ILLINOIS POWER COMPANY

CLINTON POWER STATION, P.O. BOX 678, CLINTON, ILLINOIS 61727

Subject: Illinois Power (IP) Company Request for Concurrence to
Remove Additional Commodities from the Overinspection
Program

ENCLOSURE 1
TECHNICAL JUSTIFICATION FOR IP'S REQUEST
FOR NRC CONCURRENCE TO TERMINATE
THE OVERINSPECTION PROGRAM FOR
ADDITIONAL COMMODITIES

FIGURE 1

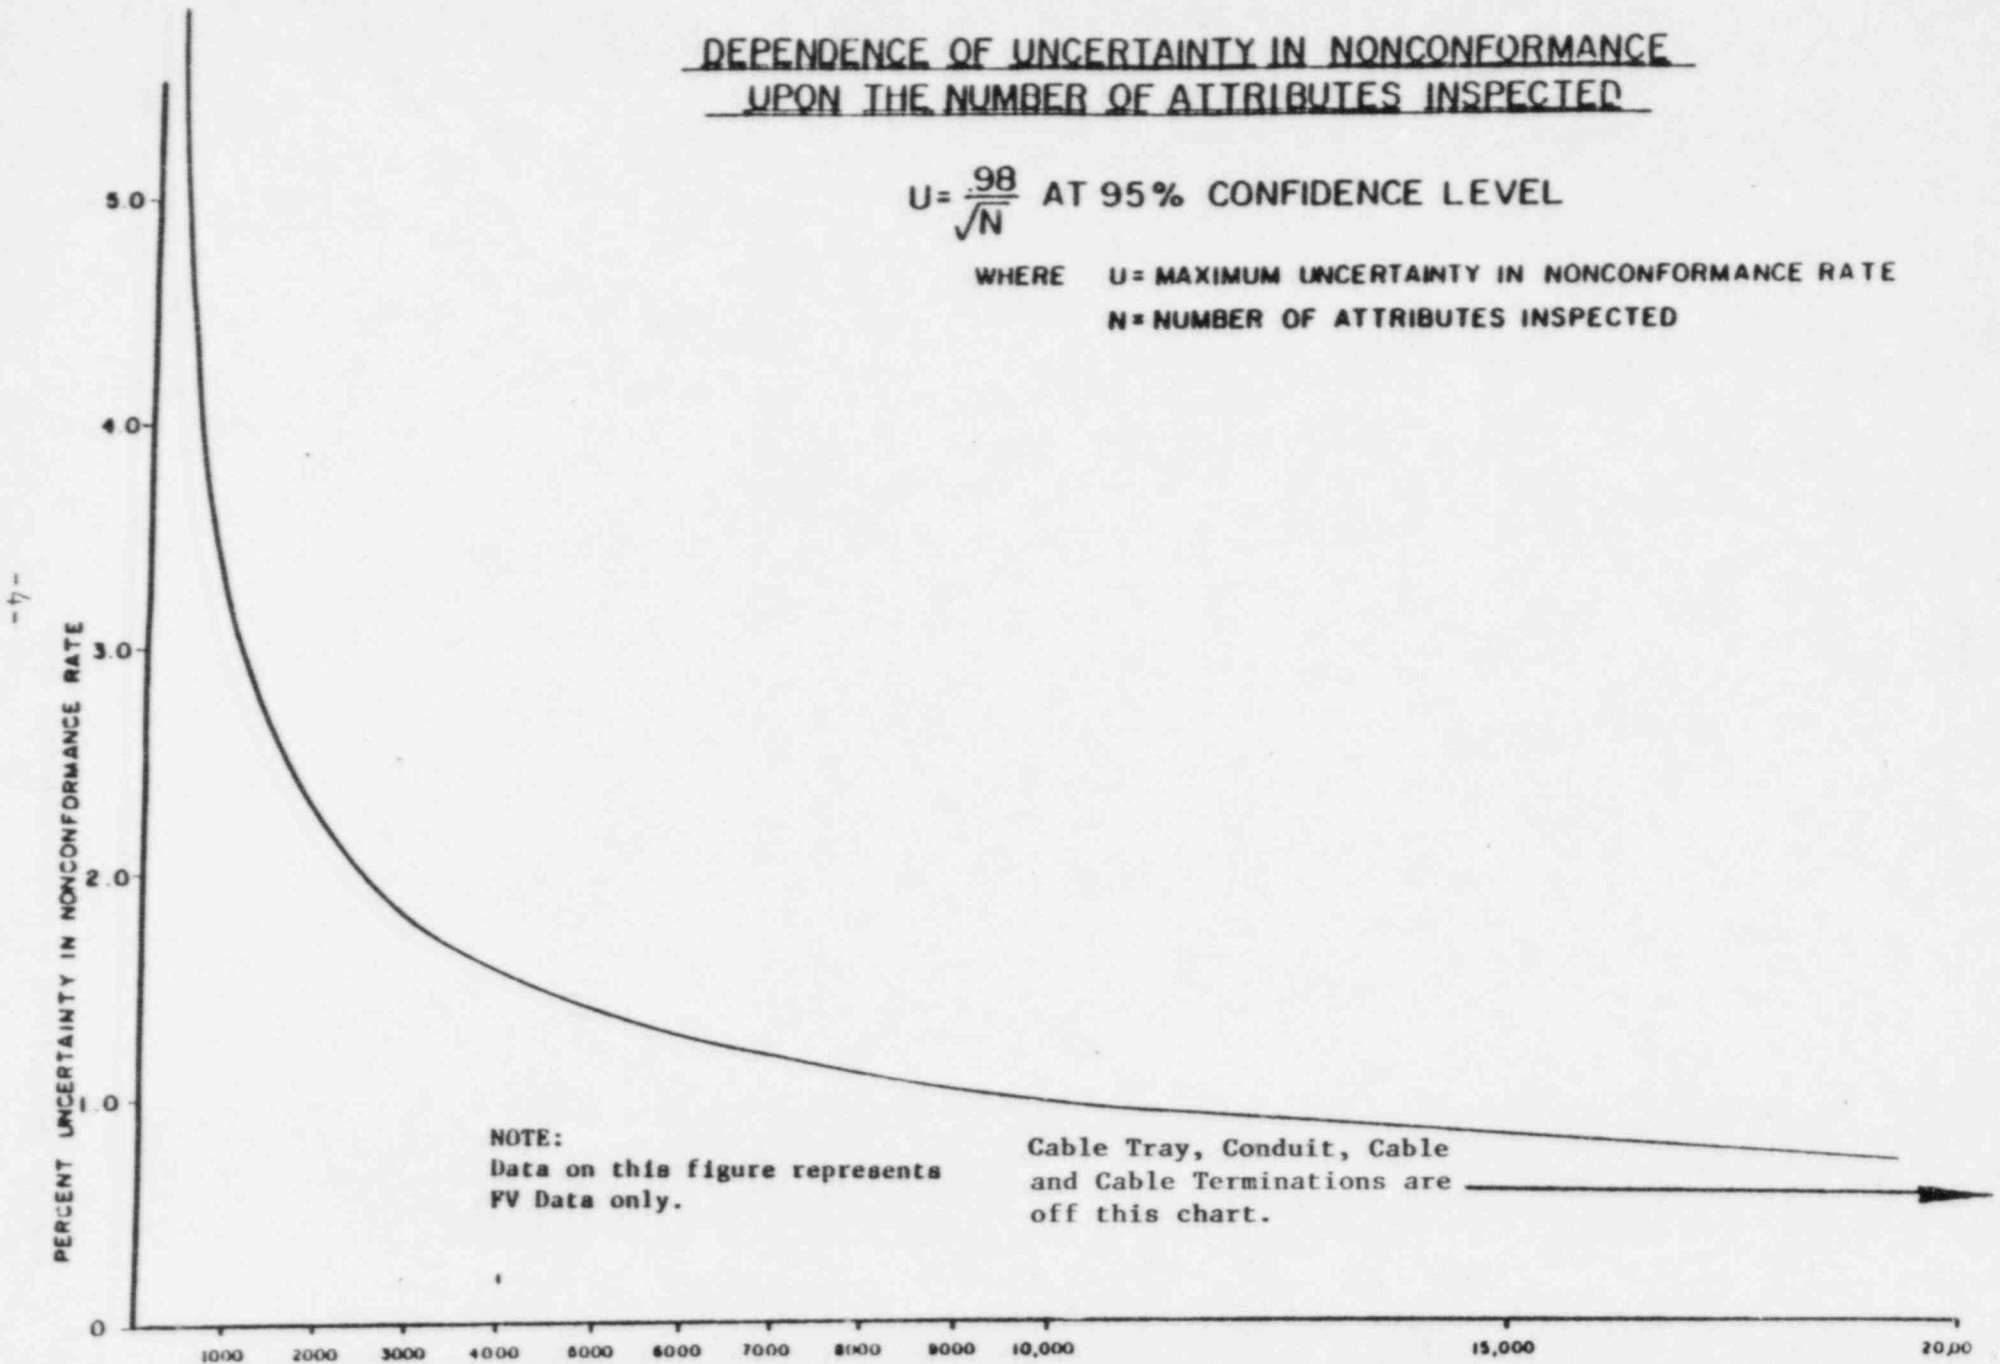
Based on the number of attributes inspected for each commodity, Figure 1 shows that the uncertainty associated with the reinspections is low, and further inspections are not expected to significantly reduce this uncertainty. In addition, Figure 2 shows that the 95/95 criterion, which is the basis for Overinspection Program sample inspection, is also satisfied for cable tray, conduit, cable and cable terminations.
